Re: FCC ID QISC218-800

Applicant: Huawei Technologies Co., Ltd

Correspondence Reference Number: 24865

**Table 1.3-1. Test Configuration Combinations**

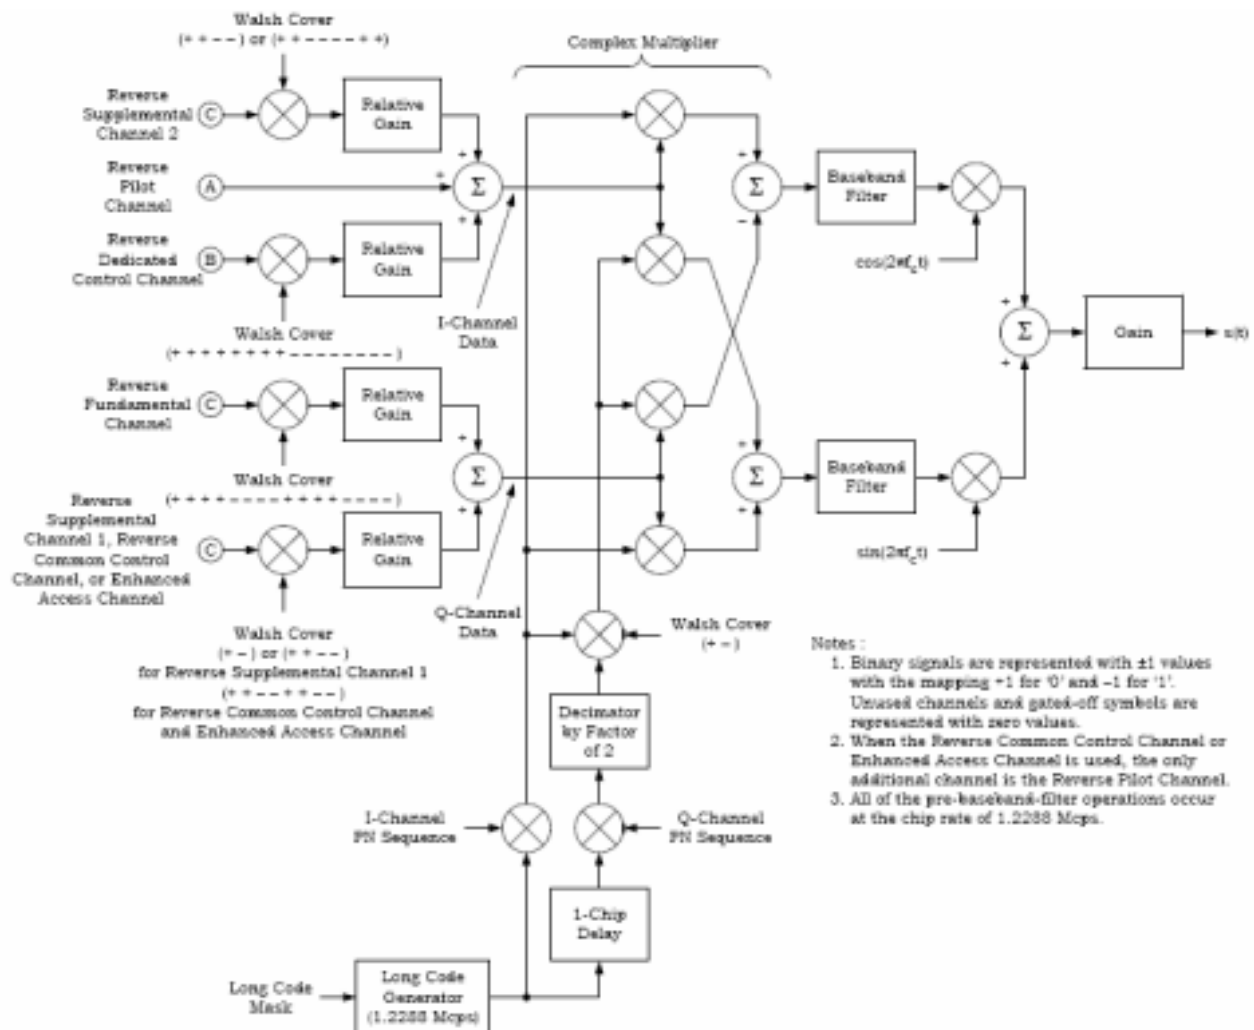
*For the forth question: I noticed that the frequency change for worst case power varies considerable with the different RCs. Since only RC3 was SAR tested some additional SAR testing may be necessary to fully justify compliance. Please see Supplement C and related Public Notices on handling different modes of operation.*

According to the test data we provided last time, the power level has little difference with the different RCs configuration in the same frequency. Although a little different with frequency, we do all tests from high, middle, low frequency in the work band. Different RCs have the different modulations for the base band referred to the document provided last time. But for RF band, the gain of the amplifier is the same in the same frequency. During the SAR test, we did pre-scan test firstly, we found little influence between different RCs. For RC3 is the most typical configuration in the CDMA2000 network condition now for C218, we used the RC3 as the worst case configuration in the test report.

Another attestation is according to 3GGP2 C S0011-B, the chapter 4.4.5.2 about test method told us:

1. Connect the base station to the mobile station antenna connector as shown in Figure 6.5.1-4. The AWGN generator and the interference generator are not applicable in this test.
2. For each band class that the mobile station supports, configure the mobile station to operate in that band class and perform steps 3 through 35.
3. If the mobile station supports Reverse Traffic Channel Radio Configuration 1 and Forward Traffic Channel Radio Configuration 1, set up a call using Fundamental Channel Test Mode 1 (see 1.3) with 9600 bps data rate only and perform steps 6 through 8.
4. If the mobile station supports the Radio Configuration 3 Reverse Fundamental Channel and demodulation of Radio Configuration 3, 4, or 5, set up a call using Fundamental Channel Test Mode 3 (see 1.3) with 9600 bps data rate only and perform steps 6 through 8.
